<b>AMENDMENT OF SOLICITATION/MODIFICATION OF CONTRACT</b>			1. CONTRACT ID CODE <b>OP-ES</b>	PAGE OF PAGES 1   13	
2. AMENDMENT/MOD NO. 7	3. EFFECTIVE DATE 10/26/09	4. REQUISITION/PURCHASE REQ. NO.		5. PROJECT NO 98600	
NASA Procurement Office, OP-ES John F. Kennedy Space Center Kennedy Space Center, FL 32899		7. ADMINISTERED BY Same as Block 6		CODE OP-ES

The purpose of this amendment is to answer Bidder Questions, amend contract specifications, and provide informational use only drawings.

4. **REFERENCE:** Drawing S-514 (10C00003), detail Brace Bottom Plate

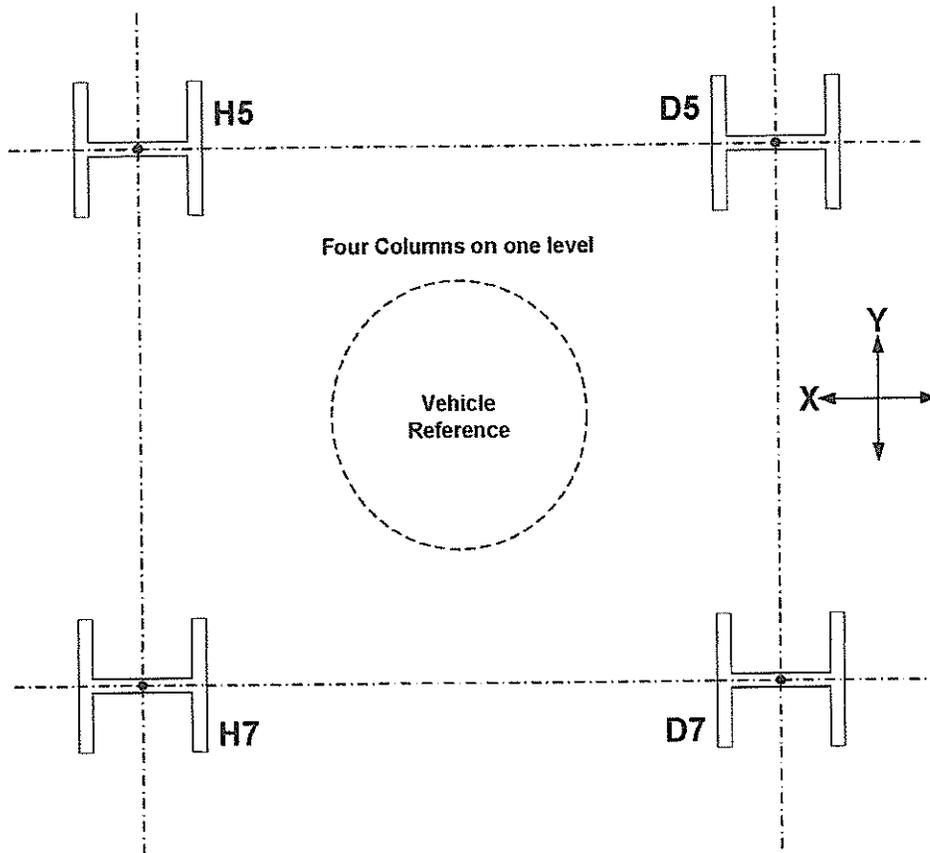
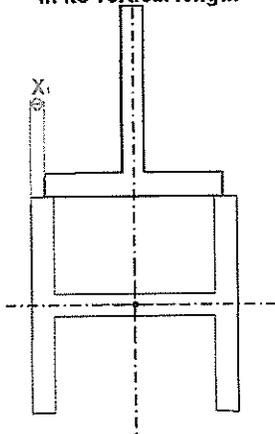
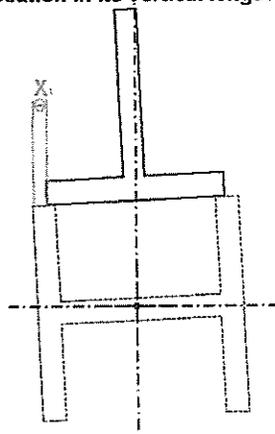
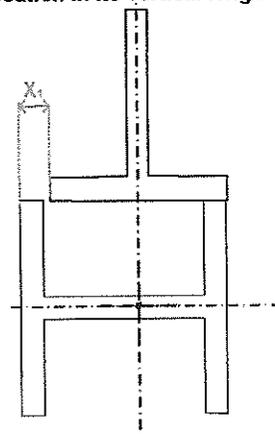
**QUESTION:** As illustrated in the attached sketch and as depicted in Detail RC on S-514 of the structural drawings to make the proposed knife connections work each of the four existing columns H5, D5, H7, and D7 must be in a highly accurate location (+/- 1/16") in relation to the geometric reference to the other three columns on that level and be very square in configuration. This set of four columns on each level then in turn relies upon the same four points in each of the other ten levels to not only be geometrically the same but in line at each of the four points at all eleven levels. It is understood that the intent of the slotted holes as depicted in details RA and RD on S-514 of the structural drawings is to account for such existing anomalies but even if one of the existing columns is turned slightly somewhere in its vertical length a minimum of 1 degree this represents 1.36 feet off center at the next column from hitting centerline the way it is depicted. The typical variations in steel structures that are allowable under applicable industry standards will be greater than this and will create much greater problems installing the welded knife connections as depicted. This does not take into account if the four columns H5, D5, H7, and D7 are any geometric shape other than a square (parallelogram etc). This also does not take into account the two existing columns near the H3, D3, H9, and D9 column lines and there geometry in relation to the existing columns H5, D5, H7, and D7. Is there an "As-Built" of columns H5, D5, H7, D7, columns near H3, D3, H9, and D9 layout? Is there a detail that can be released to the prospective Contractors to estimate that will allow for the actual physical geometry of columns H5, D5, H7, D7, columns near H3, D3, H9, and D9?

**ANSWER:** *At columns H5,D5,H7 and D7 in addition to the horizontally slotted bolt holes in the welded beam end plate, there are vertical minimum 1" thick plate spacers between the angles and the welded beam end plate that are required for the RC and RD connection installation. These spacers can be made wedge shaped to account for possible twist of the columns. Wedge shaped washers will also be needed for the bolts.*

*As an alternative or in case of a dramatic twist in the columns, welded spacers may be provided between the WT and the existing columns at one edge of the WT.*

*Near columns H3, D3, H9 and D9 the existing vertical members with existing bolt holes at 6 inches O.C. at detail RZ we have provided long horizontally slotted bolt holes in the support bracket and in the welded beam base plate. The slotted holes in the base plate are perpendicular to those in the bracket.*

*We are not aware of any existing as-built or survey that would provide the level of detail needed to determine the location of all of the column flange edges for all of the conditions. See Sheet S-001 "General Notes: Structural" Note 4.*
